Building for a Healthy Life: FINAL

Land at Eakring Road

Client: DrSK
Date: 24.02.21
Option: A
Units: 85

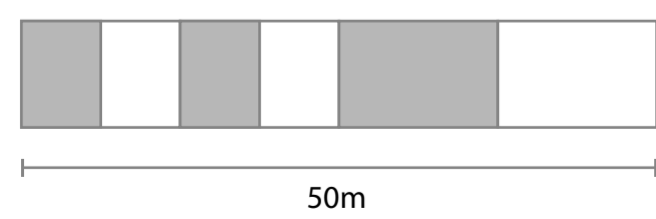
Green and blue infrastructure	Red	<p>The design response fails to demonstrate how the scheme will positively contribute towards the requirements of this consideration.</p> <p>The water management strategy is reliant on a single attenuation basin, for which there is little information. How will this function as an attractive and accessible part of the open space network? Precedents would offer the council assurances and an indication of what is envisaged. The information provided suggests that a heavily engineered solution is proposed, with steep side profiles and exposed</p>

<p>concrete headwalls. It is questioned whether there is scope to attenuate across the site, slow water flow and in turn reduce the size of the basin. There seems to be scope to create a swale/ditch along the site' eastern boundary where there is currently a narrow ditch.</p> <p>The scheme fails to demonstrate that consideration has been afforded to enhancing and creating new and linked habitats. The western hedgerow could offer greater value if replanted, laid and/restored. New open spaces could introduce species rich grasslands.</p> <p>More thought and creativity is required to meet the requirements of this consideration.</p> <p>A red light is justified.</p>
<p>Back of pavement, front of home</p>	<p>Amber</p>	<p>The proposals fail to fully meet the requirements of this consideration.</p> <p>The distinction between public and private spaces is not clear in places, with areas of left over land with no clear public or private ownership and function.</p> <p>There is no information within the submitted proposals that demonstrates that the space between the back of the pavement and the façade of individual homes will be detailed in order to create a good quality street environment. For instance, a high proportion of homes sit >2m of the pavement edge. These spaces are often poorly resolved with a lack of space to allow any landscape to flourish or be practically maintained. Such spaces often become neglected and are characterised by bare patches of earth, threadbare landscaping and utility boxes.</p> <p>There is no robust waste storage strategy with no dedicated areas for storing waste and recycling containers. Whilst there is space to the side of detached homes to locate containers, this is less so for semi-detached and terraced typologies where space is limited and largely consumed by car parking spaces. Whilst there is space within some plots for storage within garden spaces, for these to be accessible and used requires careful consideration. For instance, there need to be clear movement corridors to allow bins and crates to be dragged/carried and a sufficient area of hard surfacing. It is also important to be mindful of the need to provide visually discreet locations where garden storage is used.</p> <p>Mid terraces rely on residents dragging and carrying containers long distances. For example plot 94 needs to navigate four tight right angle turns to reach their rear garden space. The awkwardness of the route and the length of this route will (in reality) see the occupants storing their containers within the 2m space between the edge of the private drive and the façade of the building.</p>

Land at Eakring Road

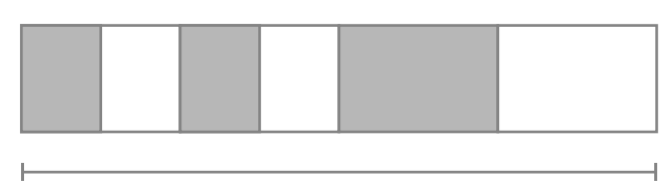
• Different building typologies would allow homes to address all edges of this development block; however the concept utilises Keepmoat building forms. This edge of the development block would require careful resolution to avoid rear garden boundaries facing onto the public realm.
